Joseph M. Farley Nuclear Plant  
Response to Request for Additional Information Related to Power Uprate  
Facility Operating Licenses and Technical Specifications Change Request

SNC Response to NRC Request For Additional Information  
Related To Power Uprate Submittal - Joseph M. Farley Nuclear Plant, Units 1 and 2

SNC RESPONSES TO NRC QUESTIONS RESULTING FROM  
NRC/SNC CONFERENCE CALLS ON FEBRUARY 10 AND 13, 1998

Figure 1

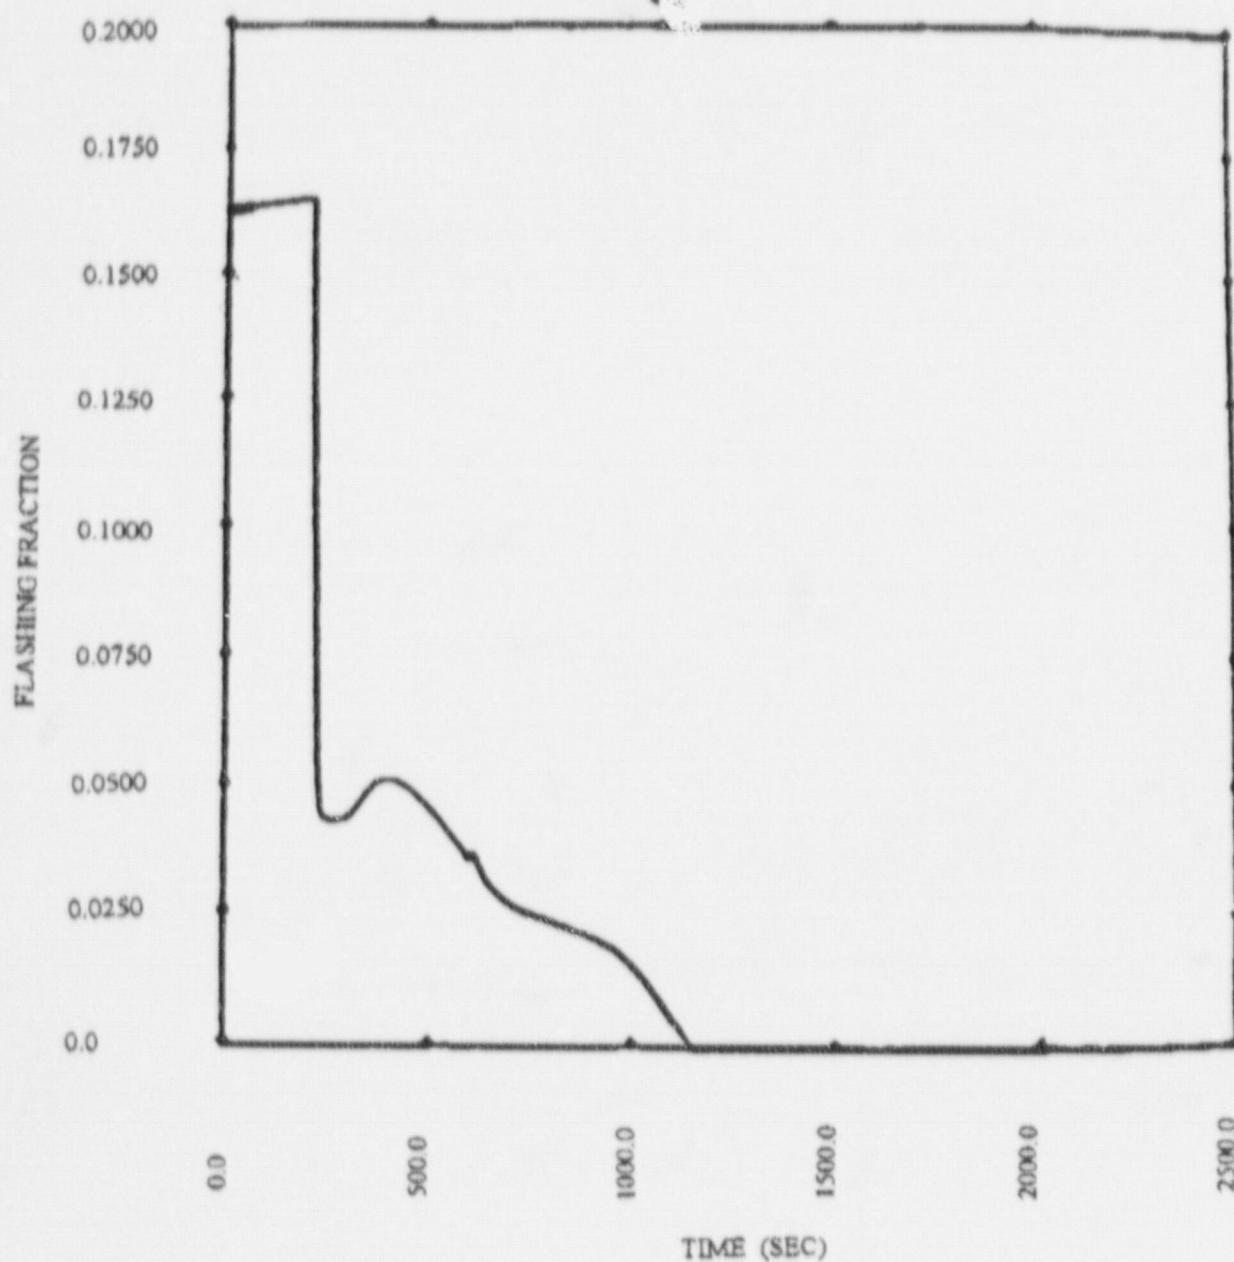
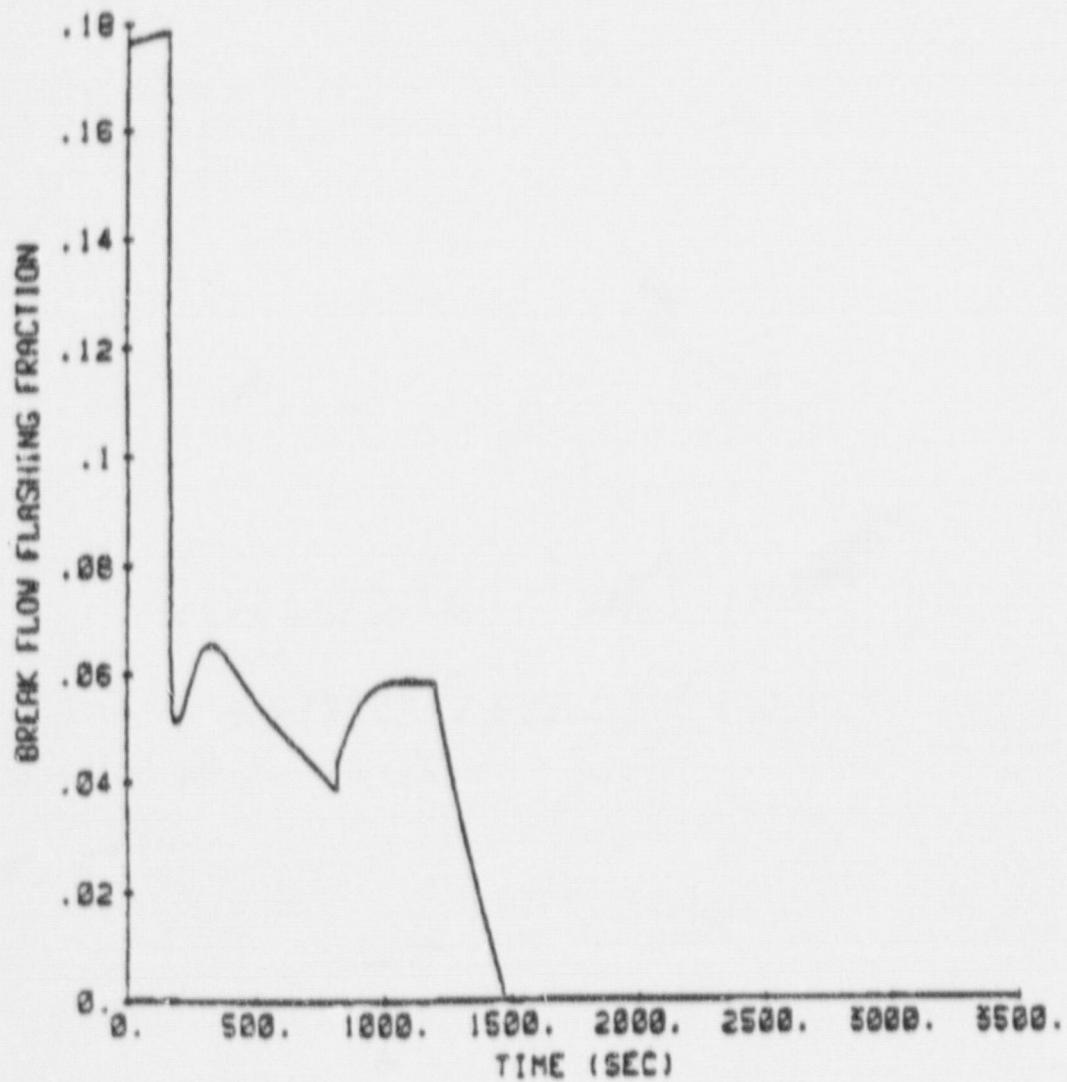
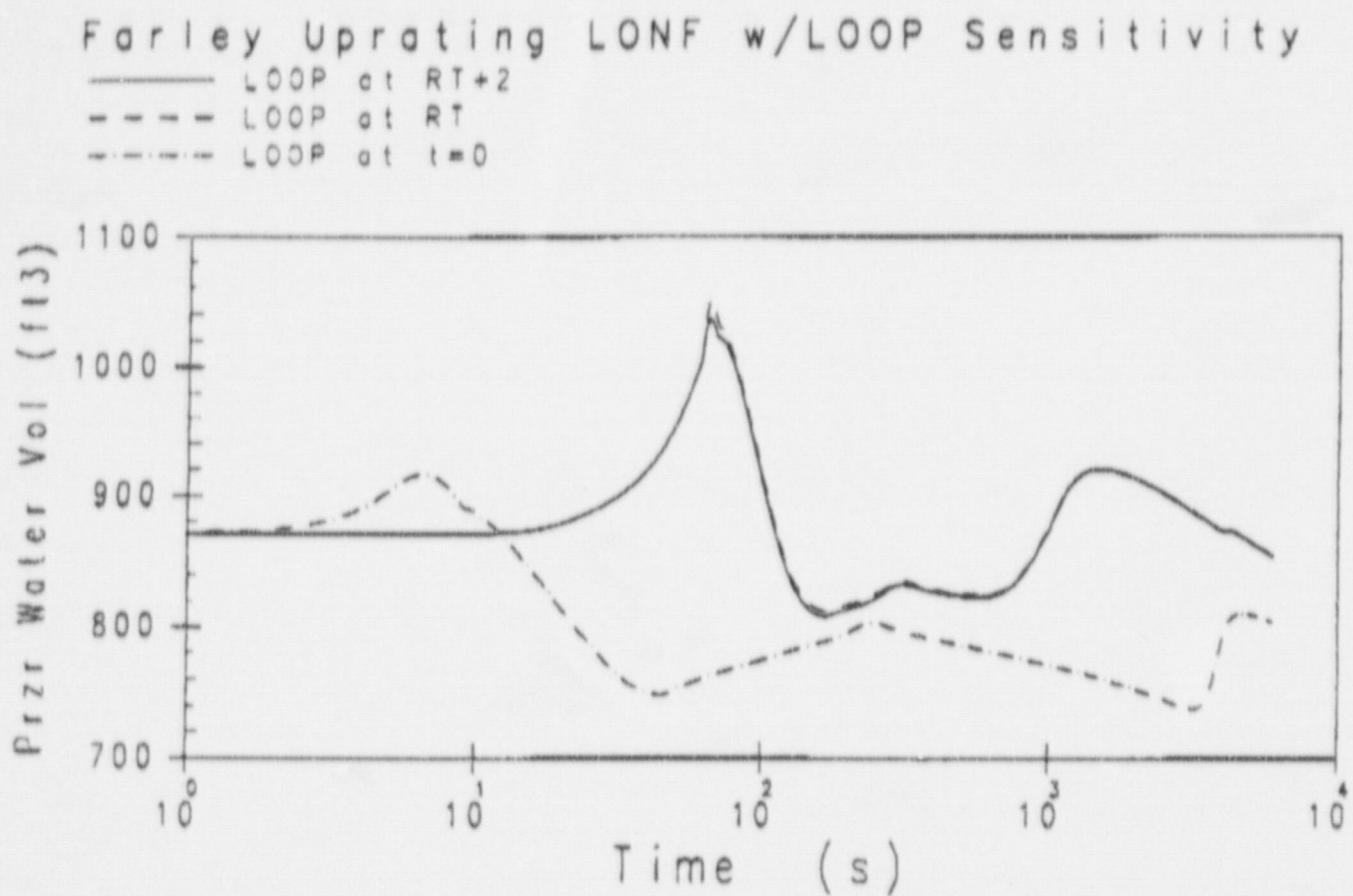
Provide the flashing fractions as a function of time in the faulted steam generator for the SGTR accident for two cases. In the first case, the PORV for the faulted steam generator is assumed to fail closed. In the second case, the PORV for the faulted steam generator is assumed to fail open. In both cases, the onset of the SGTR event is assumed to occur coincident with a loss of offsite power.

The Farley SGTR analysis does not include flashing fractions as a function of time. As requested by the NRC Staff, the attached figures provide examples of the break flow flashing fraction as a function of time for detailed SGTR transient analyses performed for plants which include flashing in the licensing basis calculation. These transients model the expected operator actions to terminate primary to secondary break flow, including isolation of the ruptured steam generator, cooldown with the intact SGs and depressurization with the pressure PORV. Figure 1 assumes that a PORV on an intact SG fails closed. Figure 2 assumes that the PORV on the ruptured SG fails open and requires operator action to close the associated PORV block valve. Both analyses assume a loss of offsite power. The loss of offsite power assumption for these analyses is the same as for Farley, which is discussed in Section 6.3 of WCAP-14723.

The evaluation statements made above were verified with several LOFTRAN simulations. (LOFTRAN is an NRC approved non-LOCA Code.) The results of these simulations are graphically shown on the attached figure. Figure 3 shows a plot of pressurizer volume versus time for the FEAR case (LOOP at reactor trip plus 2 seconds), LOOP at reactor trip, and LOOP at event initiation. Note that the two cases LOOP at RT plus 2 seconds and LOOP at RT are essentially the same. Assuming the LOOP at event initiation is not limiting
